Support Document for the Revised National Priorities List Final Rule – PROTECO

**Support Document for the
Revised National Priorities List
Final Rule
PROTECO
May 2019**

This document provides responses to public comments received on PROTECO site, proposed on May 17, 2018 (83 FR 22918). This site is being added to the NPL based on an evaluation under EPA's Hazard Ranking System (HRS) in a final rule published in the *Federal Register* in May 2019.

A-1

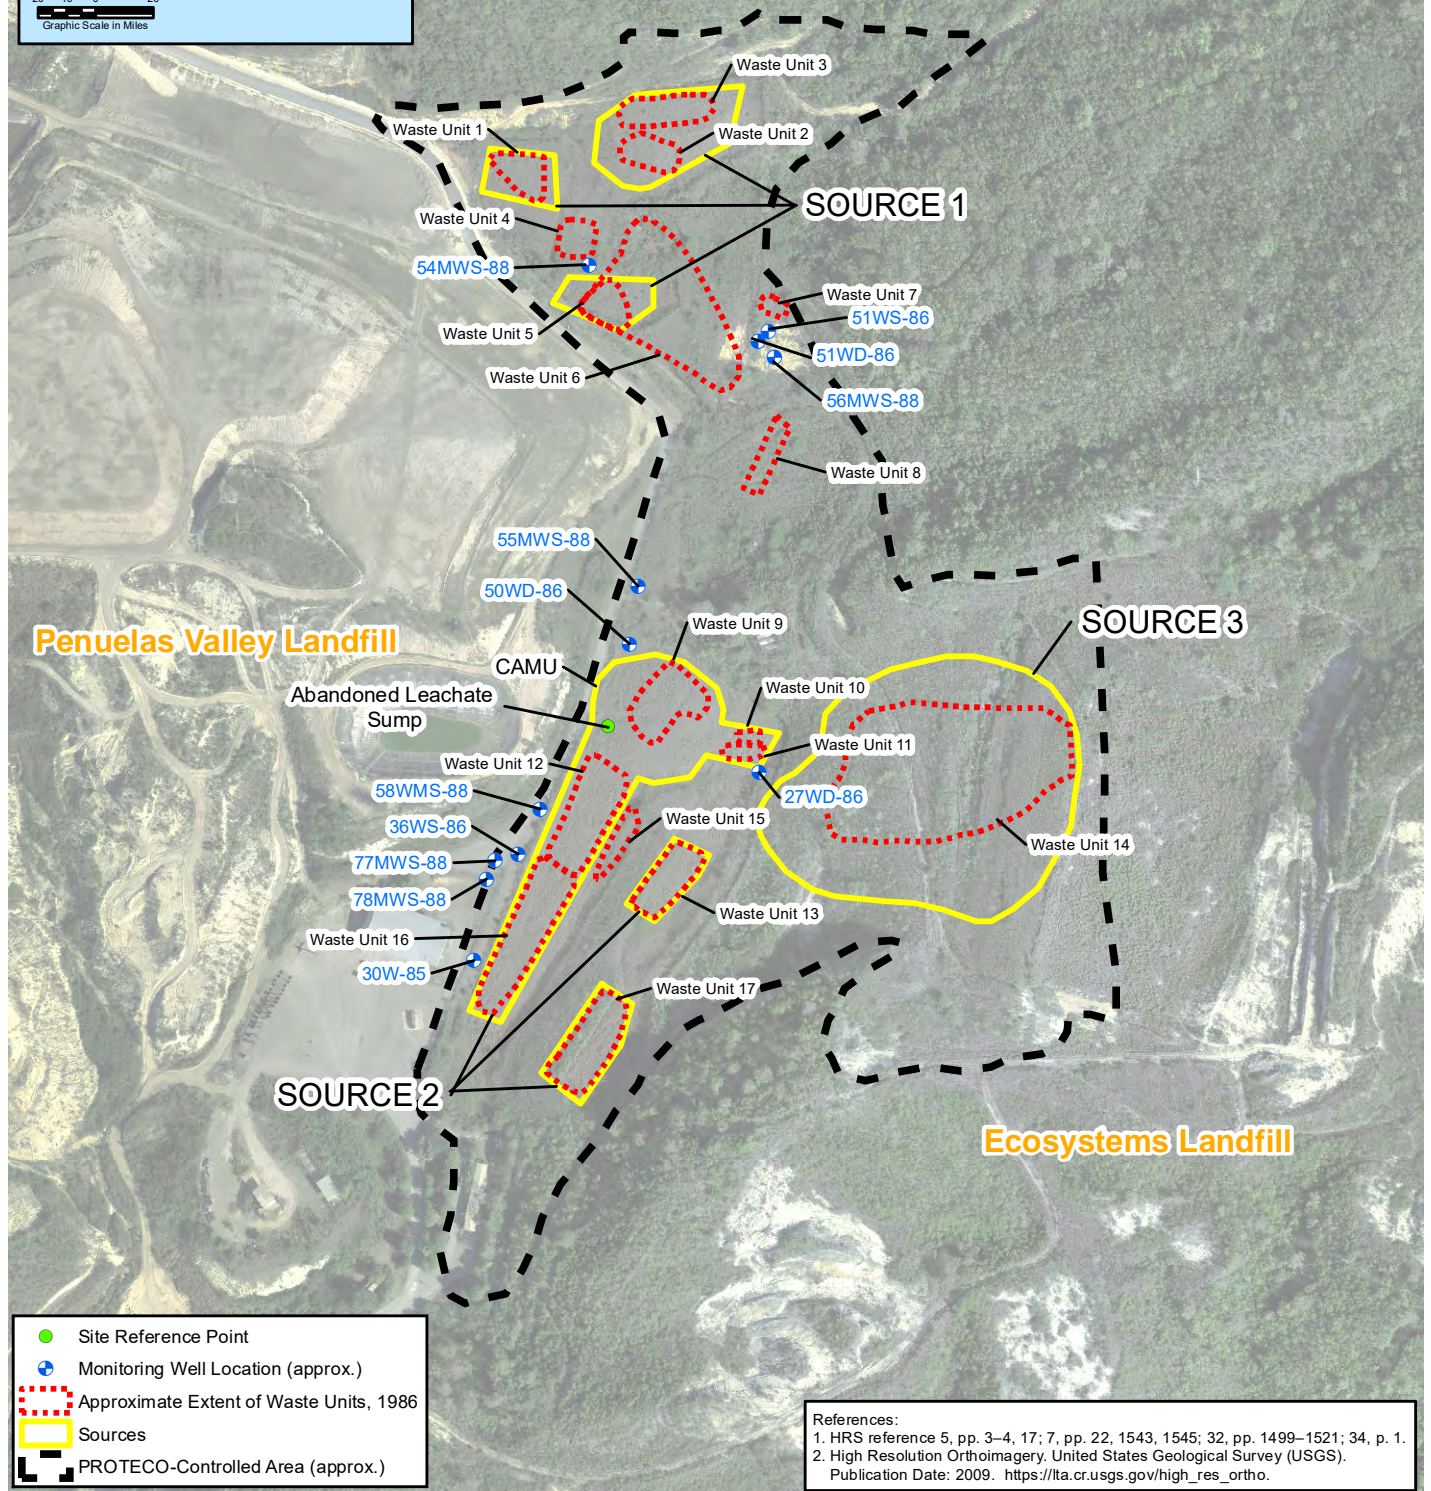
Comment: PVL and RMI both submitted comments questioning the interconnection of the Juana-Díaz and the Tallaboa aquifers within two miles of the Site. PVL commented that wells found at the Site have perched water with high specific conductance and stated that if there is a connection between the wells at the Site and those wells in the Tallaboa alluvial aquifer, one would expect higher specific conductance in the potable wells in the Tallaboa Valley. PVL commented that there is no data to support the EPA's assertion that wells constructed across an aquifer boundary (i.e., across the Juana Díaz and the Tallaboa aquifer boundary) lead to an interconnection between the two aquifers as noted in the HRS documentation record at proposal.

Response: The hydrogeological conditions at the Site are appropriately evaluated as presented in the HRS documentation record at proposal; and the Juana-Díaz aquifer underlying the facility was properly determined to be hydraulically interconnected to the alluvial Tallaboa aquifer. The EPA established interconnections, consistent with the HRS, within the alluvial and Juana-Díaz aquifer layers by documenting preferential pathways in the calcareous silty clay layer that allow groundwater to travel from the surface to the reef limestone, and documenting that contamination has been observed to migrate into the reef limestone from the above aquifer units. The EPA then documented that the reef limestone underlying the facility exhibits hydraulic gradients toward the west and northwest to the Tallaboa valley with no HRS-qualifying aquifer discontinuities identified between the aquifer units (see Figure A-1 of this support document). Therefore, the hydrogeological conditions were appropriately evaluated at the Site and it was determined that the aquifer units are hydrologically interconnected for HRS purposes.
